SERVICE BULLETIN

M-798

October 7, 1980

REAR BRAKE CALIPER MAINTENANCE 1980 & 1981 FLT/1981 FLH

Figure 1. Rear Brake Caliper - FLT Shown

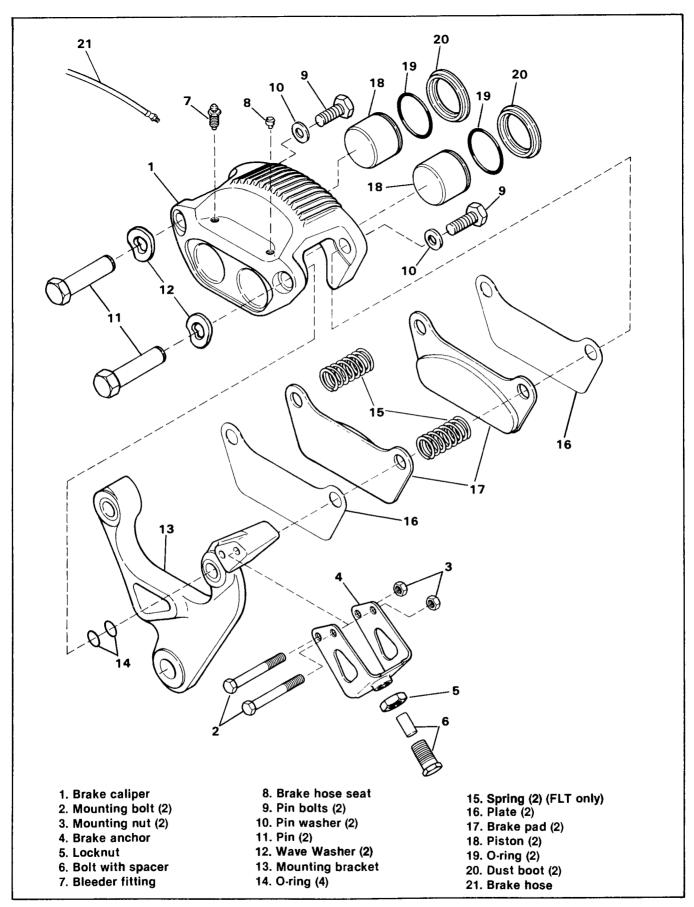
The new rear brake caliper on the 1981 FLH models is almost identical to that used on the FLT. Important differences include a different mounting bracket and the omission of the brake pad springs.

When servicing the rear brake caliper on 1980 and 1981 FLT and 1981 FLH models, a thin coat of Harley-Davidson ANTI-SEIZE should be applied to the mounting pins as described below. This will help extend the service life of the brake pads.

- 1. Remove only one caliper bolt (9), washer (10), pin (11), wave washer (12) and spring (FLT only) (15).
- 2. Apply a thin coat of Harley-Davidson ANTI-SEIZE, Part No. 99632-77, to the outside diameter of the pin (11).

The pin must be removed from the caliper to be properly lubricated. Use only enough Harley-Davidson ANTI-SEIZE to LIGHTLY coat the pin. Excessive lubricant could contact the brake disc or pads and affect brake performance.

- 3. Install the pin (11), wave washer (12), spring (FLT only) (15), washer (10) and bolt (9). Make sure the pin passes through the holes in the plates (16) and pads (17). Tighten the bolt (9) to 12-15 ft-lbs torque.
- 4. Repeat the above procedure for the other pin.
